METROPOLITAN GOVERNMENT OF NASHVILLE AND DAVIDSON COUNTY

STAFF RECOMMENDATION
1812 Holly Street
February 17, 2021

Application: New Construction—Infill and Outbuilding
District: Lockeland Springs-East End Neighborhood Conservation Zoning Overlay
Council District: 06
Base Zoning: R6
Map and Parcel Number: 08314006700
Applicant: Hunter Conley, Allard-Ward Architects
Project Lead: Sean Alexander, sean.alexander@nashville.gov

Figure 1: 1812 Holly Street, before the tornado.

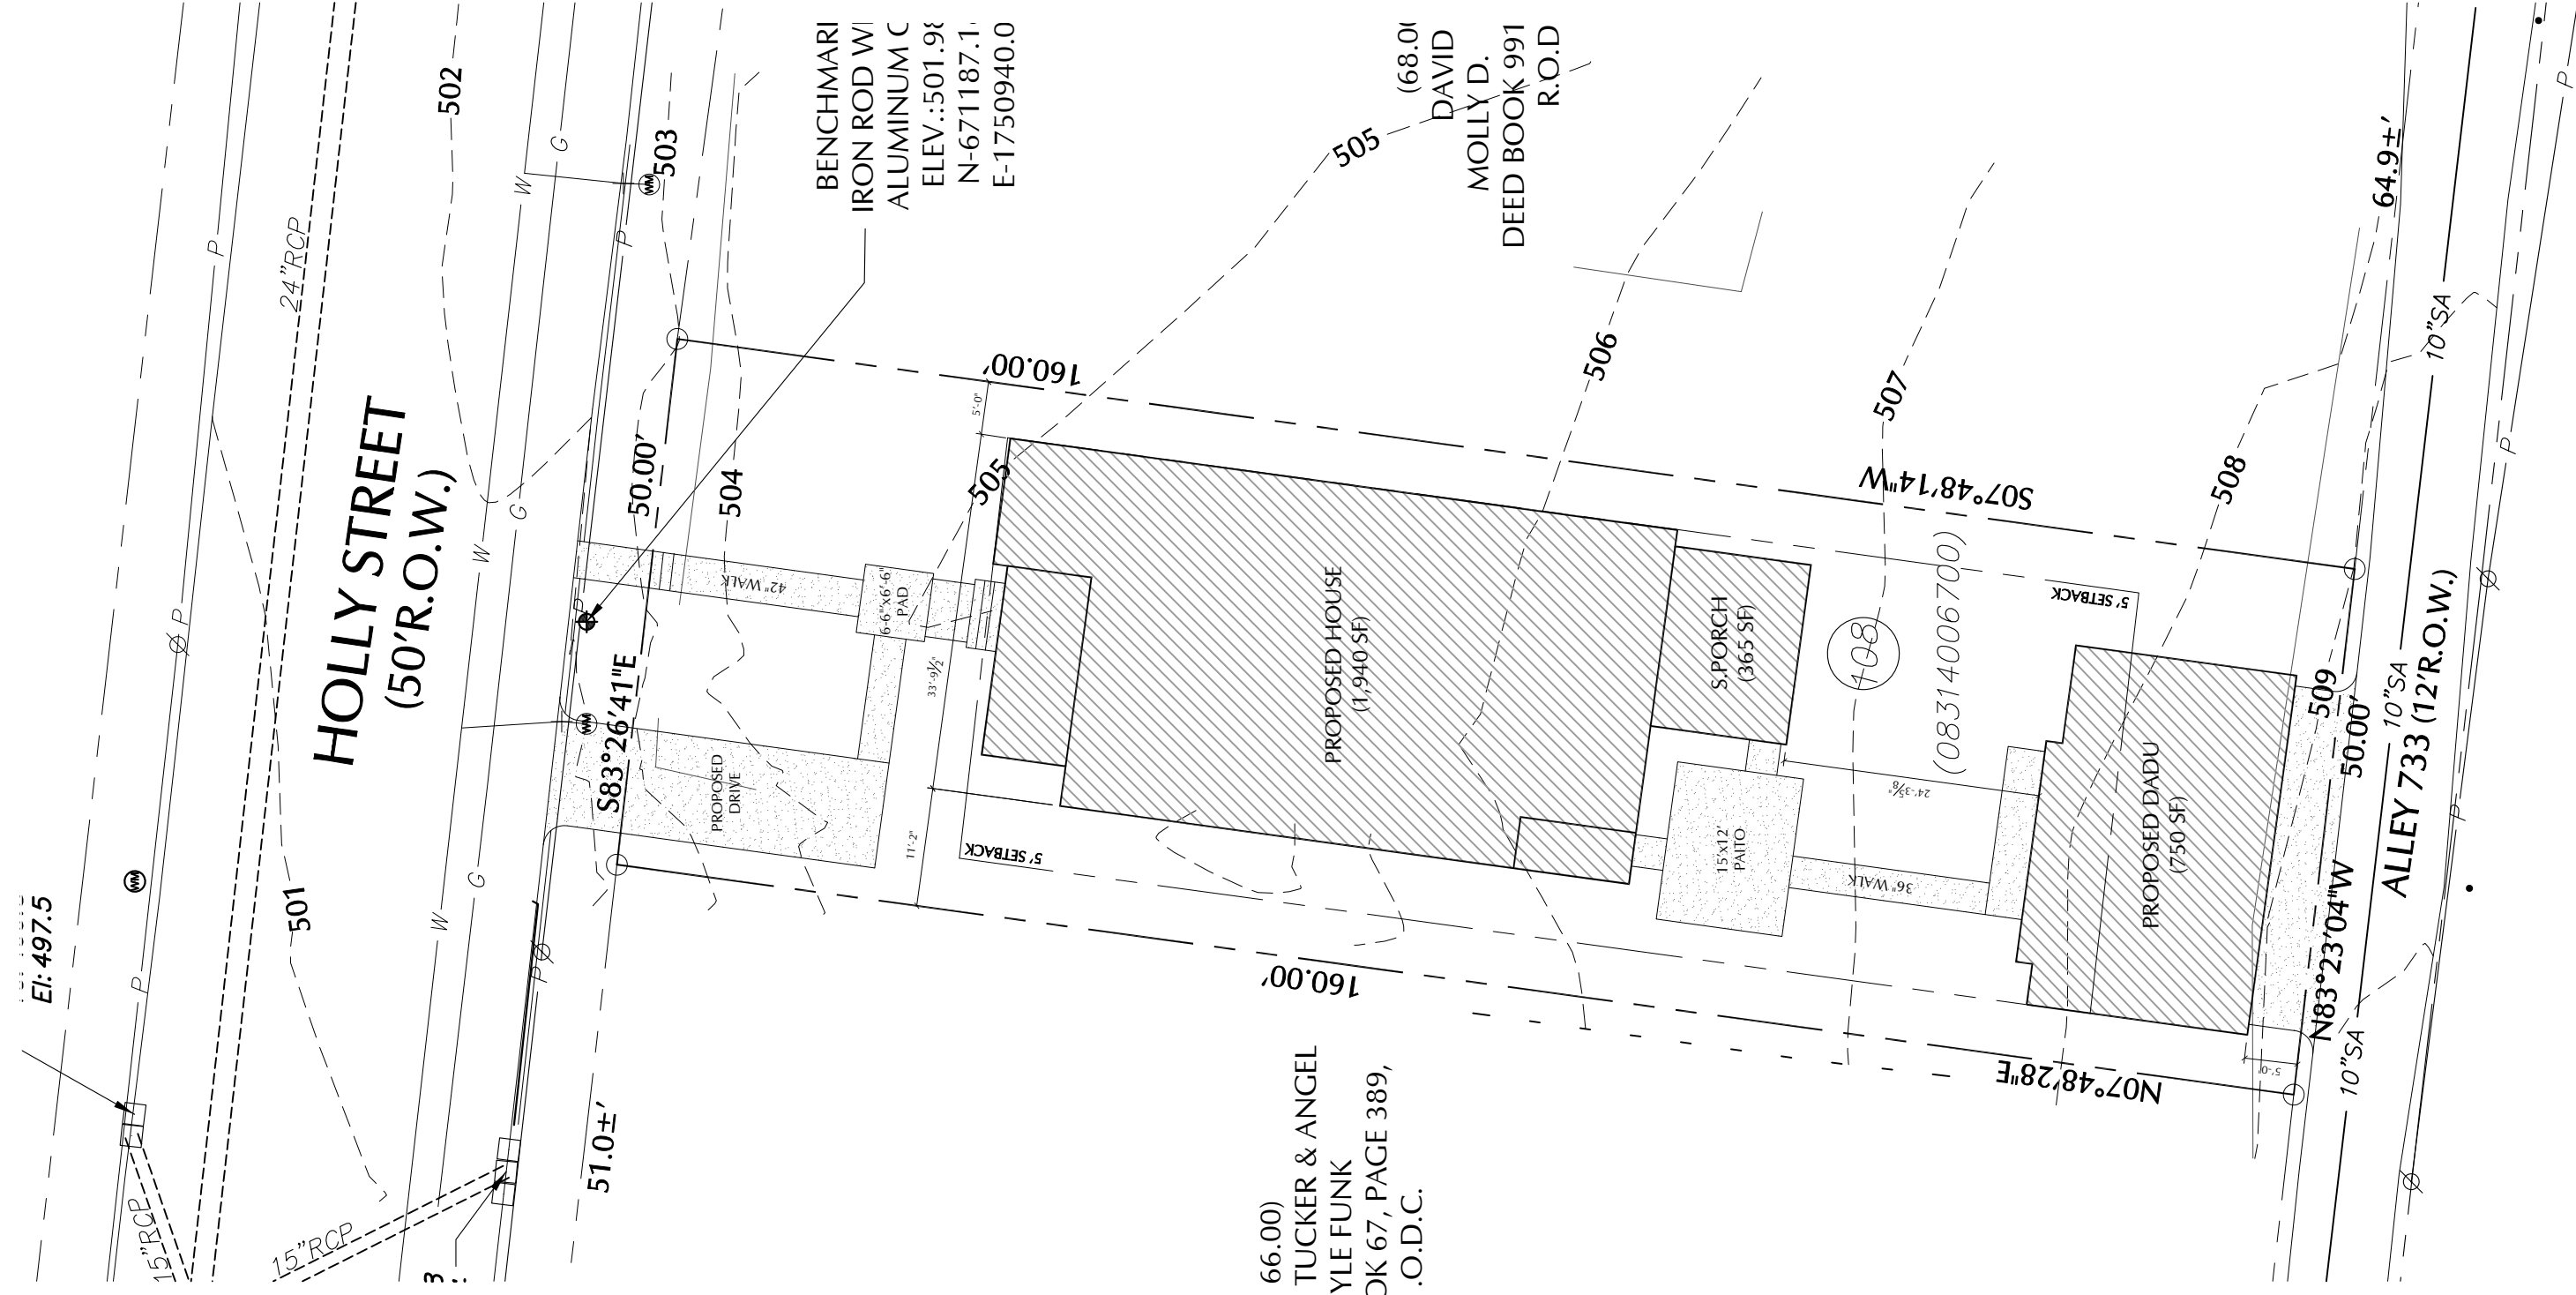
The building at 1812 Holly Street, a one-story Craftsman Style house, was severely damaged.

MHZC staff issued an emergency demolition permit under the Rules of Order and Procedure VI.C.2.c, which allow for administrative issuance of demo permits for any structure that has become a major life-safety hazard.

Drawings: Elevations	Date: 01.12.21
-------------------------	-------------------

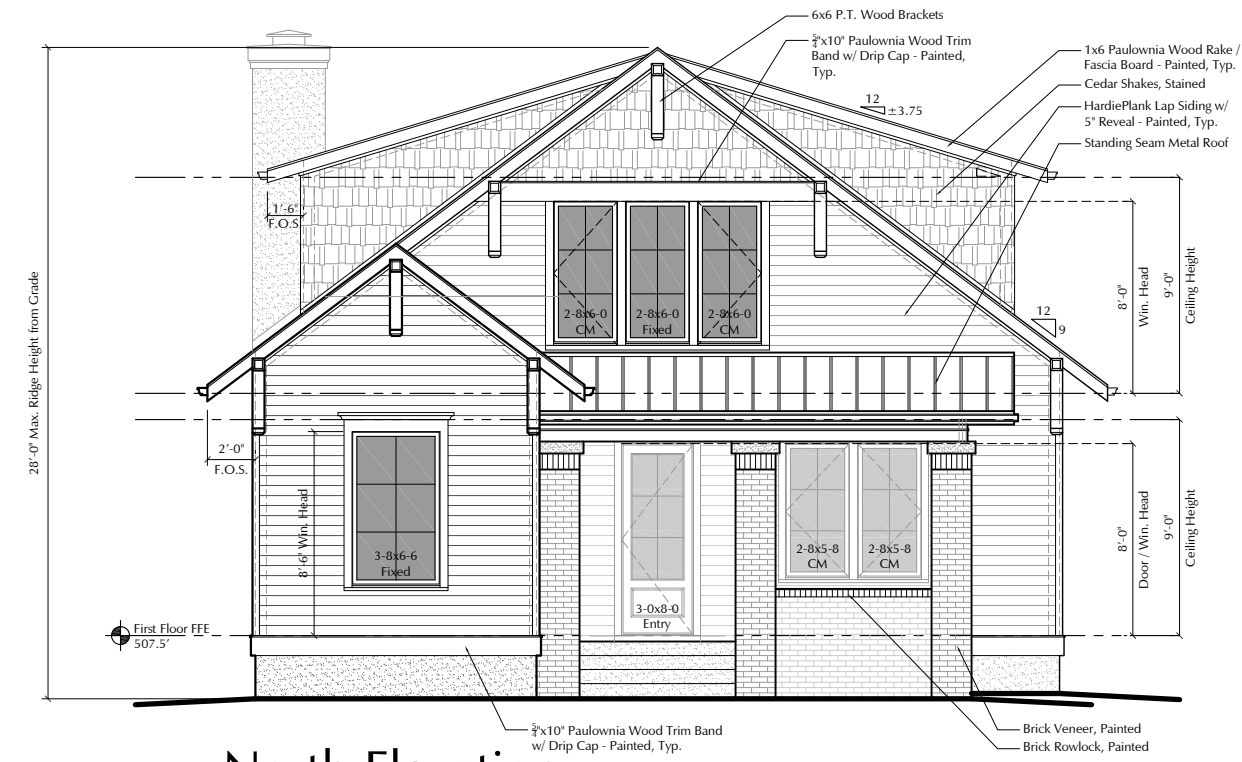
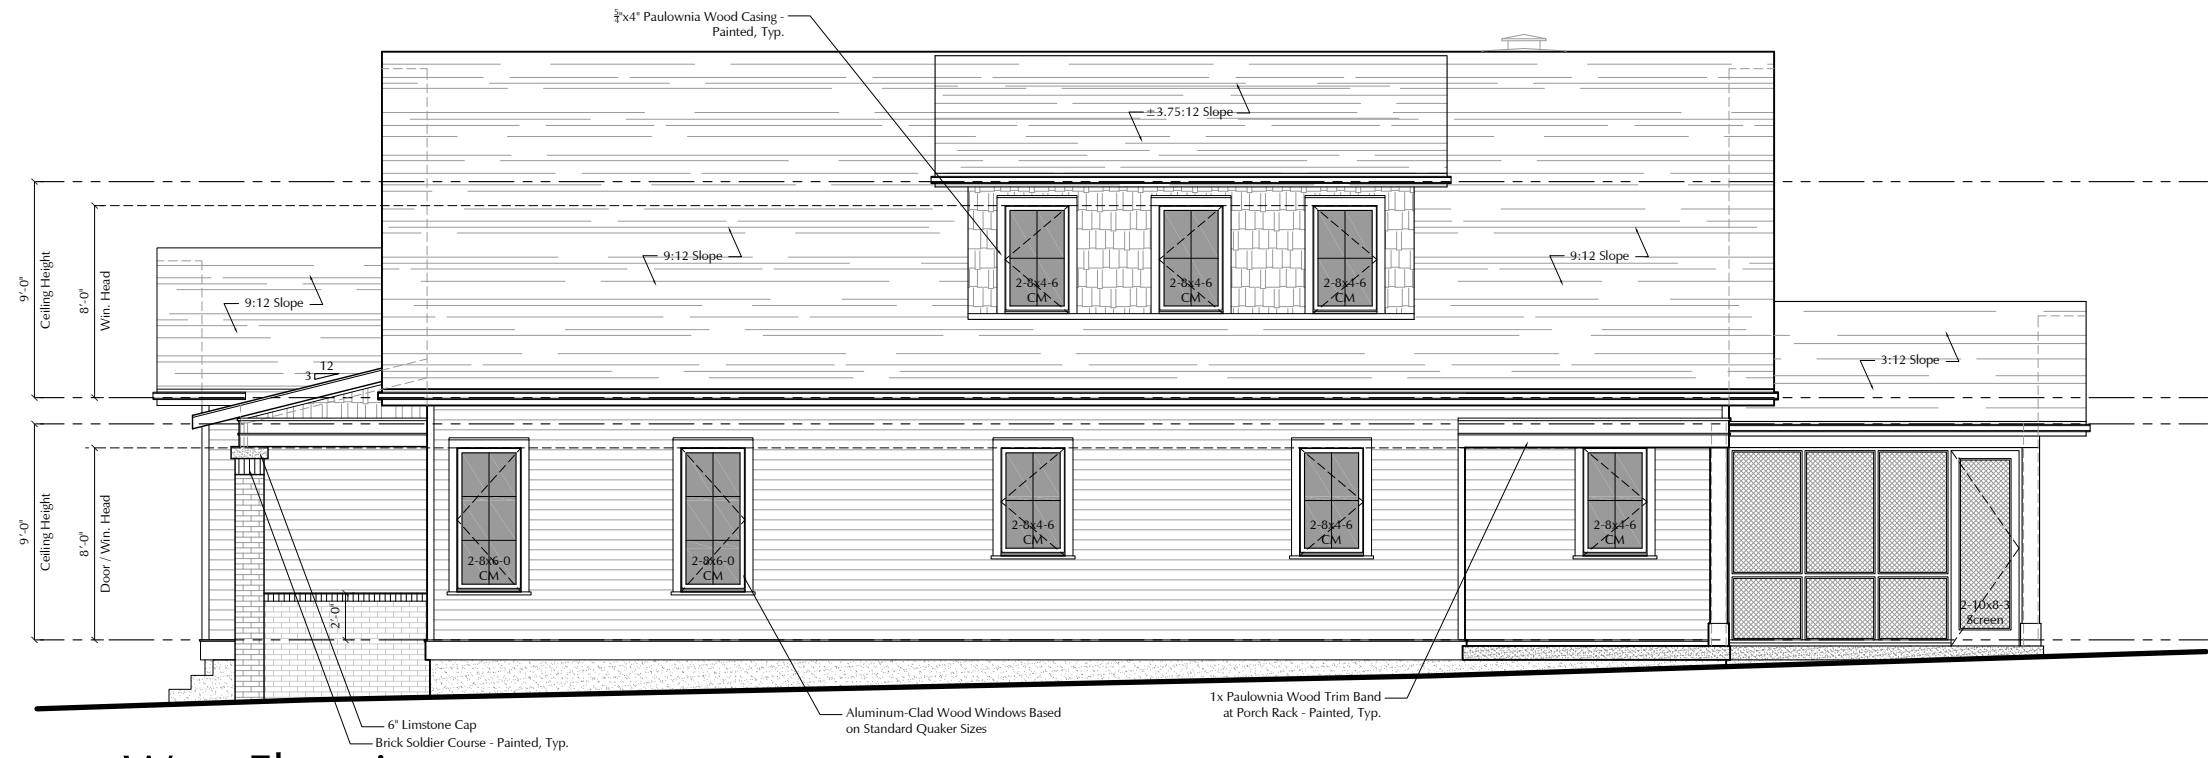
Height & Scale: The new house will be one-and-one-half-stories, with a roof-ridge height of twenty-four feet, six inches (24'-6") from the floor level, or twenty-seven feet (27') from grade. The finished floor level will be two-feet, eight inches (2'-8") above grade at the front, with twenty-two inches (22") of exposed foundation and a ten inch (10") skirt board. Four steps will lead from grade up to the porch floor, matching the number of steps on the previous structure, and consistent with the adjacent house. The historic context on this block is composed of one-and-one-half-story houses ranging from twenty-one feet (21') tall to twenty-eight (28') tall. The eave height will be twelve feet (12") which is approximately six inches (6") higher than the eaves of the previous structure. Staff finds that the height of the proposed new one and one-half-story house is compatible with the surrounding context.

Roof form: The roof of the building will be a front-gabled form with a pitch of 9/12, with a shed dormer on each side with a 3.75/12 pitch, and a 3/12 shed roof on the front porch. The roof pitches are compatible with roofs on historic houses on the block, which includes several Craftsman houses with similarly forms.

Proportion and Rhythm of Openings: The windows on the front, sides, and rear of the building will be vertically oriented, with no large expanses of walls between openings. These proportions and the window rhythm are compatible with historic houses.

With a condition that Staff verifies that the foundation is consistent with the adjacent historic house to the right, Staff finds that the height, width, and massing of the proposed new building is appropriate and the proposal meets sections II.B.1 and II.B.2 of the design guidelines.

Staff finds the roofs of the proposed building to be compatible with surrounding houses and finds that the project will meet section II.B.5 of the design guidelines.

Staff finds that the proposal meets section II.B.7 of the design guidelines.

Drawings:
 DADU Elevations
 Date:
 01.25.21

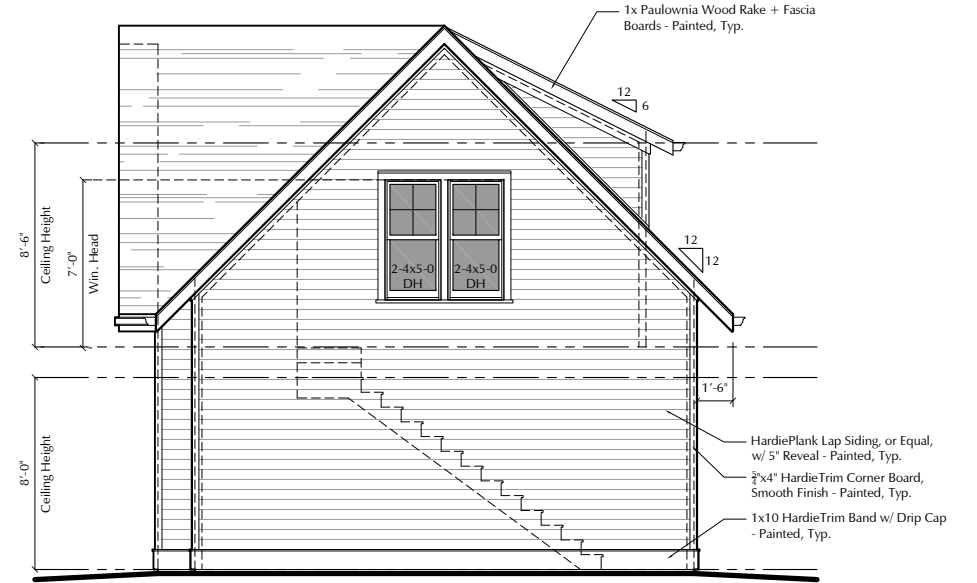
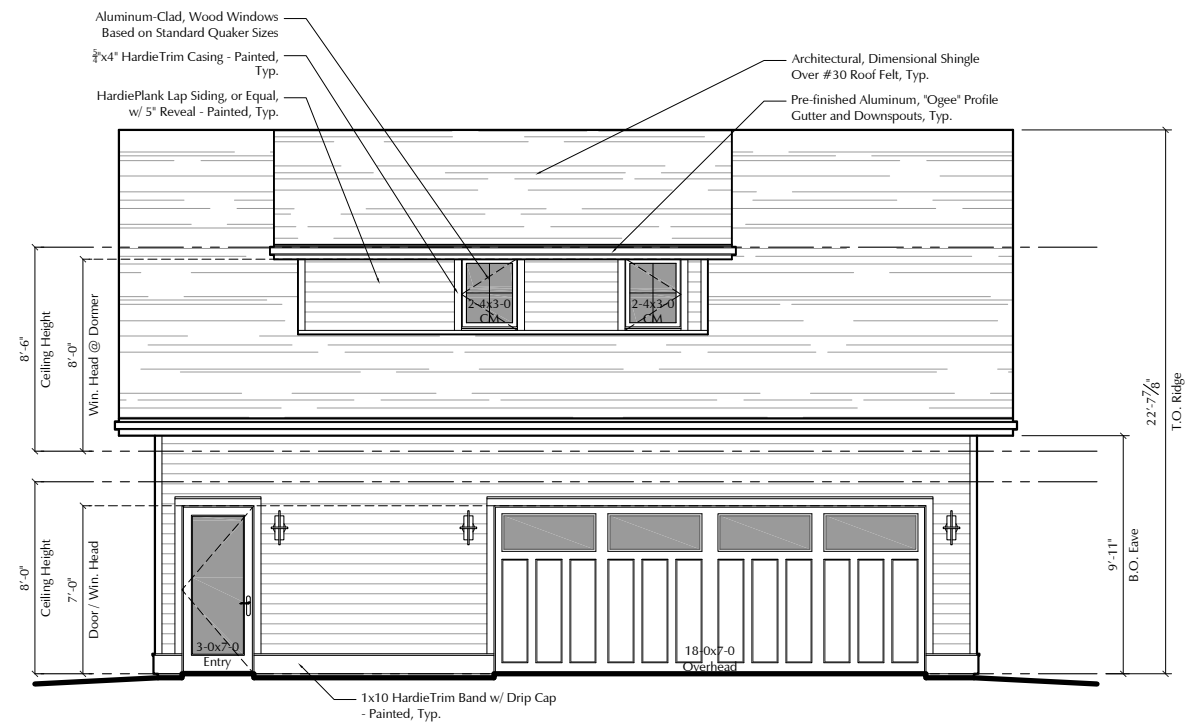
Potential 1-Story or 1.5-Story Outbuilding	Proposed Outbuilding
Ridge Height	Up to 25’(not to exceed principal building height)	22’-8”
Eave Height	10’	9’-11”

Proposed Element	Proposed Form	Typical or Appropriate?
Primary Form	Cross-gable.	Yes
Primary Roof Pitch	12/12	Yes
Dormer Form	Shed	Yes
Dormer Roof Pitch	5/12	Yes

The footprint size, roof, height, and eave heights are compatible with the corresponding heights of the house and meet the design guidelines. Staff finds that the application meets Section II.B.8.a. of the design guidelines for height and scale.

Staff finds that the roof forms of the proposed outbuilding meets Section II.B.8.a. of the design guidelines for roof form.
